Comments and Responses

2.1 Land Use, Zoning, and Compliance with Comprehensive Plan and LWRP

Image 1

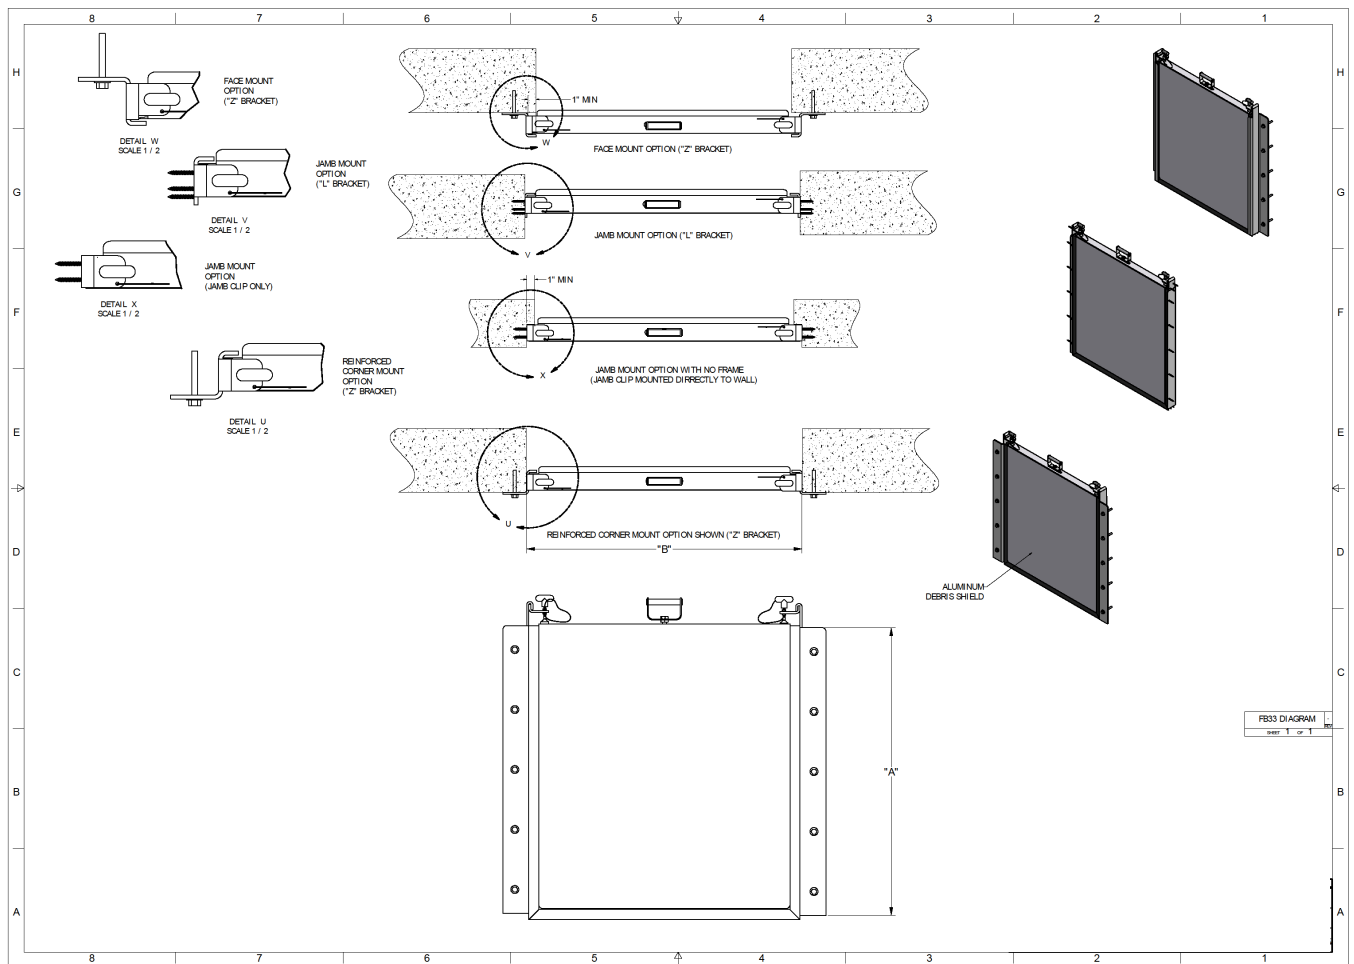
It should be highlighted that the decorative character of the openings, see Image 1, particularly the projecting, corbelled arches would be significantly damaged by the installation of any flood barriers at the openings.

Since the above information was submitted to the Village, the mill building has been demolished.

Figure 2/Option 2 – face mounted plates

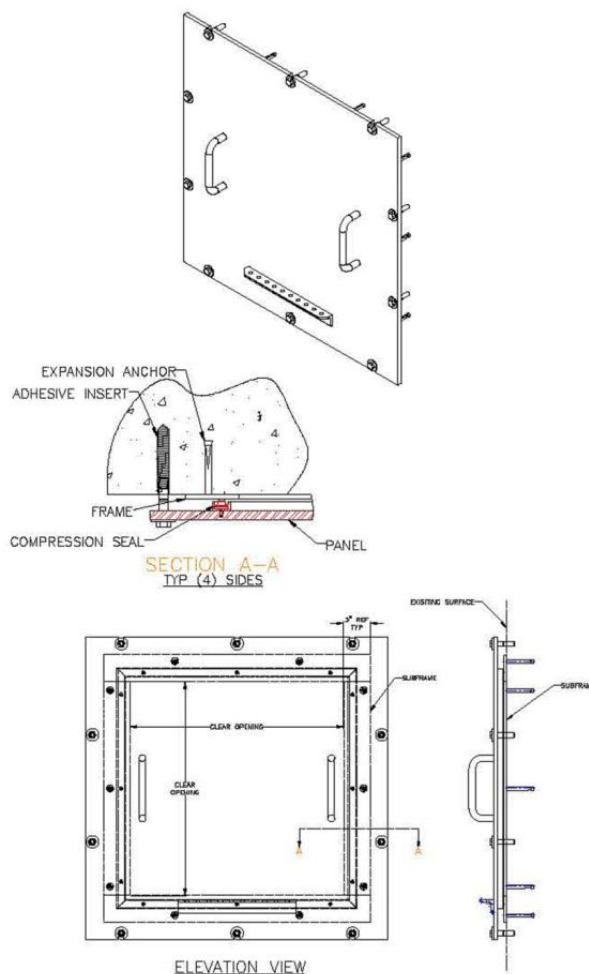
Flood barriers at openings work by providing waterproof seals around the barriers within or on frames at the openings. There are a number of options including openings framed with brackets and openings framed with plates. Those with brackets are used typically at doors. Those with plates are more appropriate for use at windows. Openings framed with brackets or plates use barriers (shields) which are affixed to the frames in time of flood. The pressure of the water against the shield enables the seals to work effectively. The brackets would need to be face-mounted into the exterior brick and rise above the window openings in order for the barrier sections to slide down within the brackets. The face-mount option on Figure 1 (Option 1) indicates how the brackets would be anchored into the exterior brick wall. Large steel brackets would surround the jambs and rest on the stone sills. Figure 2 (Option 2) indicates the type of barrier used more typically at windows. These work with a steel plate (of similar width to the brackets) anchored into the exterior brick masonry. Barrier panels are then screwed into pre-drilled inserts.

Both of the options require permanent metal elements (brackets or plates) anchored (by drilling) into the masonry which permanently and significantly alter the character of the openings. Most significantly, due to the projecting corbelled rowlock arches, neither alternative is feasible without major damage to the arches. Brick arches would need to be removed to install the plates flush with the façade brick (Option 1) and to permit sliding of the barriers into the brackets (Option 1). This significant masonry destruction is wholly contrary to the Secretary's Standards, particularly standard #2, which states that, "The historic character of a property shall be retained and preserved. The removal of historic materials or alteration of features and spaces that characterize a property shall be avoided". Additionally, the weight of a panel which covers a typical 1st floor window opening would be about 300 lbs. Installation of these barriers in a timely fashion requires a sophisticated, well-equipped and expensive infrastructure.
